Docket Number:	02-AFC-01C
Project Title:	Sonoran Energy Project (formerly Blythe Energy Project Phase II) - Compliance
TN #:	210635
Document Title:	SEP Revised Wastewater Disposal Method
Description:	N/A
Filer:	Jerry Salamy
Organization:	CH2M HILL
Submitter Role:	Applicant Consultant
Submission Date:	3/7/2016 5:01:34 PM
Docketed Date:	3/7/2016

**Re: Sonoran Energy Project (02-AFC-1C) Petition to Amend
Revised Wastewater Disposal Method**

**Attachment 1 - Revised Sonoran Energy Project
Petition to Amend Project Description**

FIGURE 2-4aR
Water Balance Diagram
 Sonoran Energy Project
 Riverside County, California

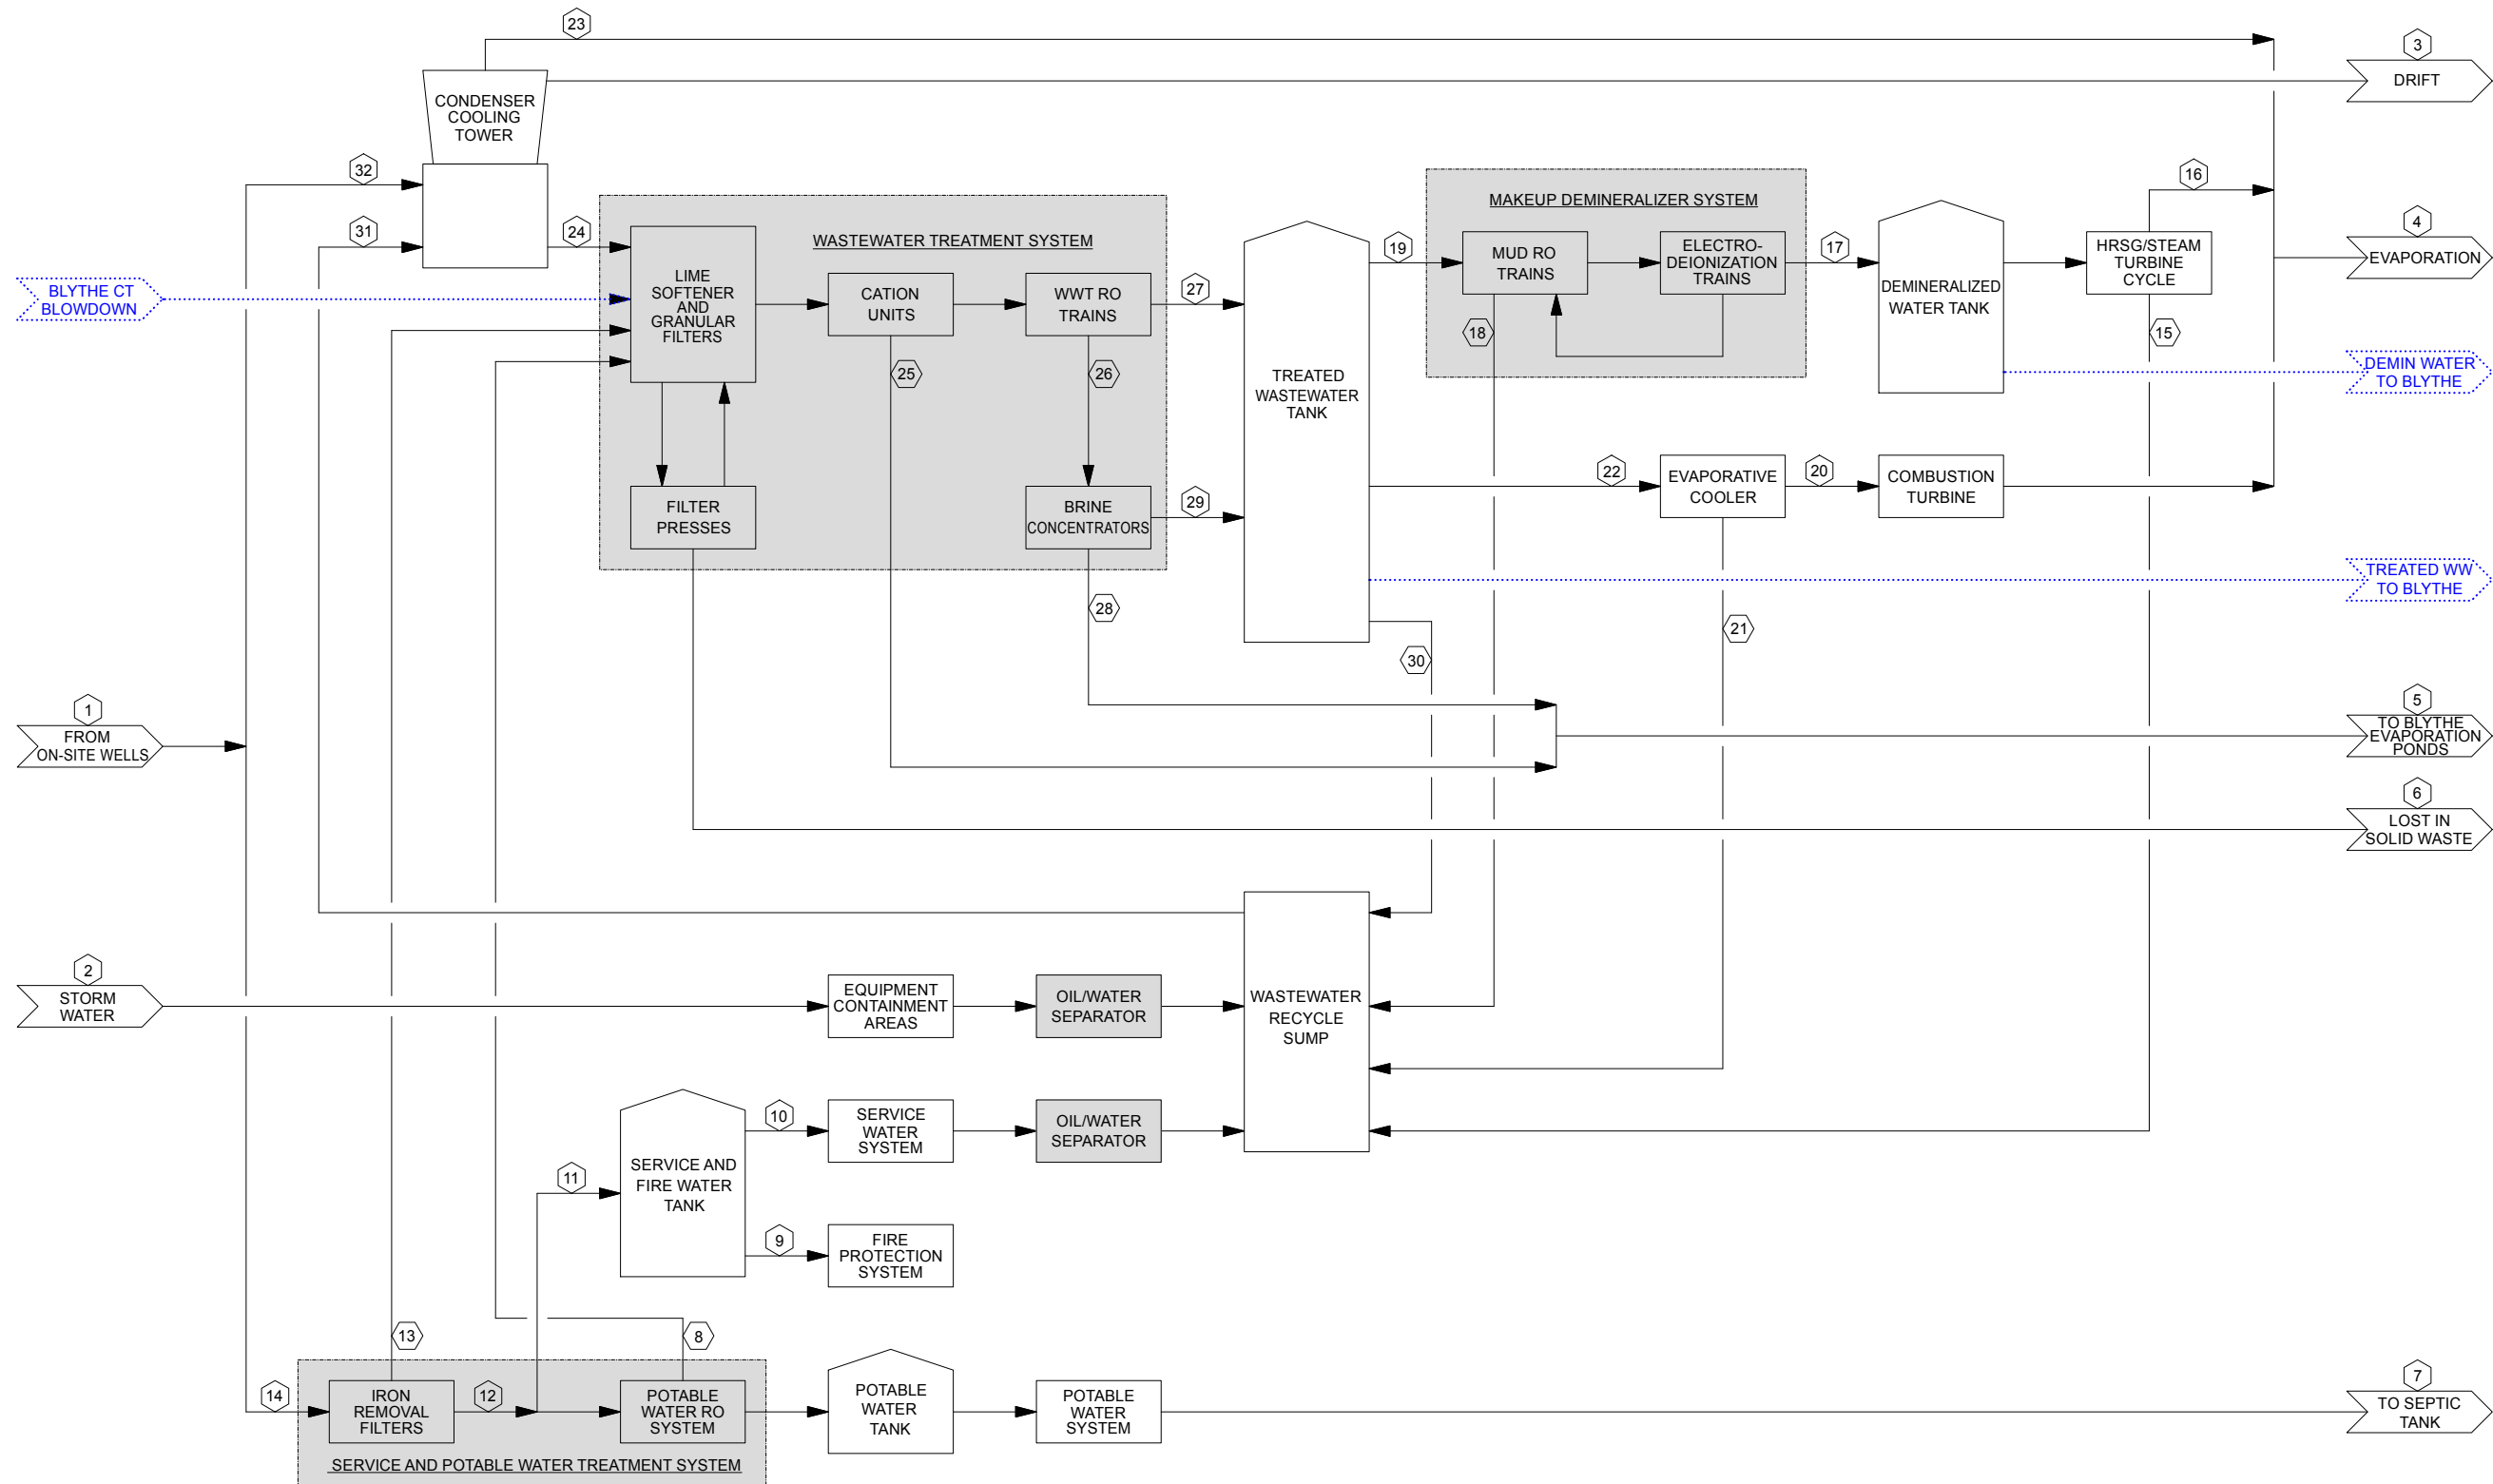
To facilitate Staff's incorporation of this proposed change in the Final Staff Assessment, AltaGas Sonoran is providing Attachment 1, a revised SEP PTA Project Description Section (Section 2.0) in underline/strikeout format to clearly define the proposed changes. Also included in Attachment 1 is a revised water balance figure (PTA Figures 2-4aR and 2-4bR).

Any water that is not adequately treated for reuse will be discharged to one of two ~~new~~ **existing** evaporation ponds **on the BEP site** for ultimate disposal through evaporation. The evaporation ponds ~~will be are~~ designed with high-density polyethylene (HDPE) liners and sufficient surface area to evaporate rainwater that falls directly in the ponds as well as water discharged from the brine concentrators **in the wastewater treatment systems at both SEP and BEP.**

At the average ambient temperature of 74 °F with evaporative cooling and no duct burner firing, discharge to the evaporation ponds **from SEP** will be approximately 14.4 gallons per minute (gpm). **Based on operation for 5,500 hours per year under these conditions, 4,752,000 gallons per year will be discharged to the evaporation ponds. Based on a summer ambient temperature of 110 °F with the evaporative cooler in operation and duct burner firing, discharge to the evaporation ponds from SEP will be approximately 20.0 gpm. Based on operation for 1,500 hours per year under these conditions, 1,800,000 gallons per year will be discharged to the evaporation ponds. The total volume discharged to the evaporation ponds from SEP over 7,000 hours of operation will be ~~or~~ approximately ~~23.1~~ **6.6** million gallons per year.**
